Access Compliance Report

Public Rights-of-Way

Intersection ID: 16439	Main Street: SOUTH_BV	Cross Street: SCALEYBARK_RD	Location: NE
ADA ID: F16BAE12746E	Ramp Type: Perp	Initial Pass/Fail: Fail	Overall Compliance: No
		Severity Score: 12.5

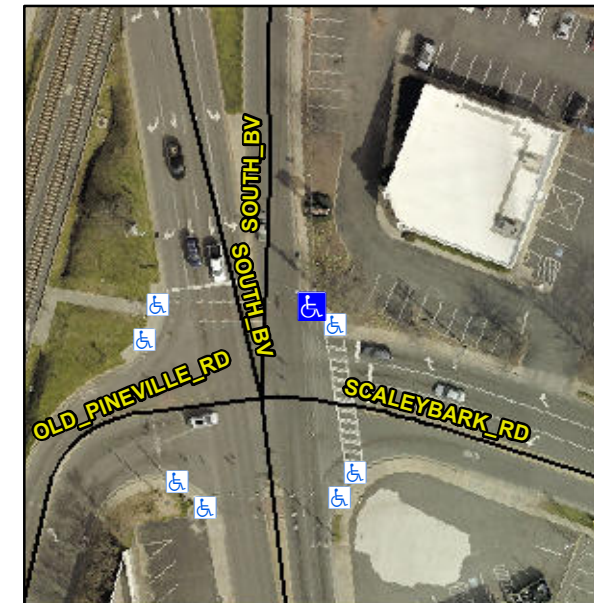
Not Found, R304.2.2

Compliance	Description	Data	Compliance	Description	Data
N/A	Ramp Length (in)	59.0	No	Ramp Slope (%)	9.0
Yes	Ramp Width (in)	49.0	Yes	Ramp XSlope (%)	0.2
N/A	Flare Type LT	N/A	N/A	Flare Type RT	N/A
N/A	Flare Slope LT (%)	N/A	N/A	Flare Slope RT (%)	N/A
N/A	Flare Traversable LT?	N/A	N/A	Flare Traversable RT?	N/A
N/A	Landing Length (in)	N/A	N/A	DWS Provided?	N/A
N/A	Landing Width (in)	N/A	N/A	DWS Contrast?	N/A
N/A	Landing Slope (%)	N/A	N/A	DWS Length (in)	N/A
N/A	Landing X Slope (%)	N/A	N/A	DWS Full Width?	N/A
N/A	Landing Curb? (Y/N)	N/A	N/A	DWS Offset (in)	N/A
N/A	Shared Landing?	N/A			
N/A	Gutter Ponding?	N/A	N/A	Gutter Slope (%)	N/A
N/A	Gutter Lip Ht (in)	N/A	N/A	Gutter X Slope (%)	N/A
N/A	Painted X Walk1?	Yes	N/A	Painted X Walk2?	N/A
	X Walk 1 Direction	To W		X Walk 2 Direction	N/A
N/A	X Walk 1 Width (in)	110.0	N/A	X Walk 2 Width (in)	N/A
	X Walk 1 Slope (%)	3.6		X Walk 2 Slope (%)	N/A
	X Walk 1 X Slope (%)	1.9		X Walk 2 X Slope (%)	N/A

Remove & Replace Entire Ramp.
